# Access Compliance Report

## Public Rights-of-Way

Intersection ID: 7556	Main Street: GEORGETOWN_DR	Cross Street: MONTEITH_DR	Location: SW
ADA ID: A61D19EF72F6	Ramp Type: Perp	Initial Pass/Fail: Fail	Overall Compliance: No
Severity Score: 8.75			
Codes/Mitigation Info/Possible Solution		Field Measurements/Component Compliance

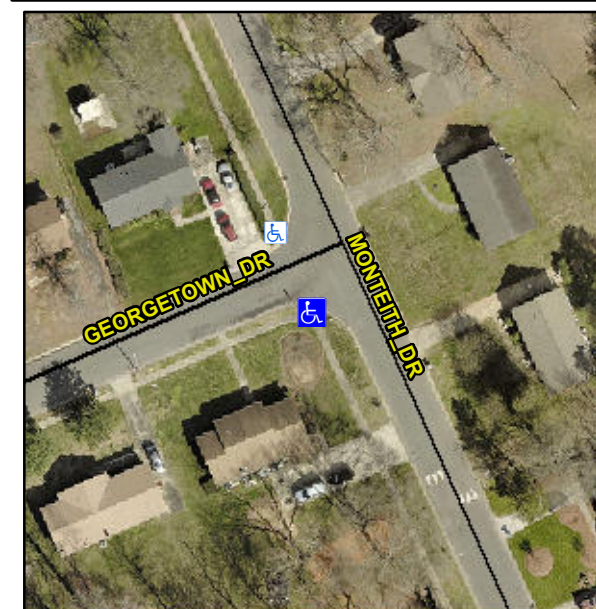
**Not Found, R304.5.1**

Compliance	Description	Data	Compliance	Description	Data
N/A	Ramp Length (in)	44.0	Yes	Ramp Slope (%)	6.7
No	Ramp Width (in)	46.0	Yes	Ramp XSlope (%)	1.0
N/A	Flare Type LT	N/A	N/A	Flare Type RT	N/A
N/A	Flare Slope LT (%)	N/A	N/A	Flare Slope RT (%)	N/A
N/A	Flare Traversable LT?	N/A	N/A	Flare Traversable RT?	N/A
N/A	Landing Length (in)	N/A	N/A	DWS Provided?	N/A
N/A	Landing Width (in)	N/A	N/A	DWS Contrast?	N/A
N/A	Landing Slope (%)	N/A	N/A	DWS Length (in)	N/A
N/A	Landing X Slope (%)	N/A	N/A	DWS Full Width?	N/A
N/A	Landing Curb? (Y/N)	N/A	N/A	DWS Offset (in)	N/A
N/A	Shared Landing?	N/A			
N/A	Gutter Ponding?	N/A	N/A	Gutter Slope (%)	N/A
N/A	Gutter Lip Ht (in)	N/A	N/A	Gutter X Slope (%)	N/A
N/A	Painted X Walk1?	No	N/A	Painted X Walk2?	N/A
	X Walk 1 Direction	To N		X Walk 2 Direction	N/A
N/A	X Walk 1 Width (in)	N/A	N/A	X Walk 2 Width (in)	N/A
	X Walk 1 Slope (%)	4.6		X Walk 2 Slope (%)	N/A
	X Walk 1 X Slope (%)	1.2		X Walk 2 X Slope (%)	N/A

**Remove & Replace Entire Ramp.**
